# Memorandum

**Date** 17 February 2006

**Subject** **Network Compliance Bulletin #10 (Underground Projects)**

**(attachment a)**

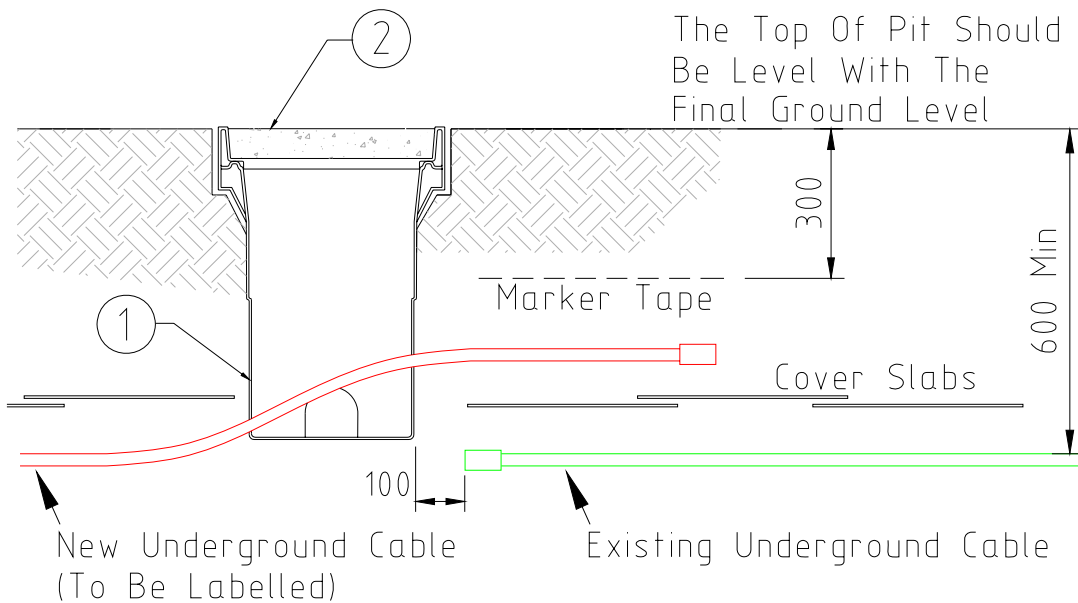
- **Personnel Safety and Electrical Asset Clearance** (Document No PCA4143.D10) has been revised, the title has been changed to **Personnel Safety and Electrical Asset Completion Notice**, the change has been necessary to eliminate any confusion with the standard Powercor HV operational clearance form. It is required that all the relevant reports / forms are attached and the current drawing number is identified, also included is a requirement to record the Permit To Work No. if applicable - (*attachment a*)
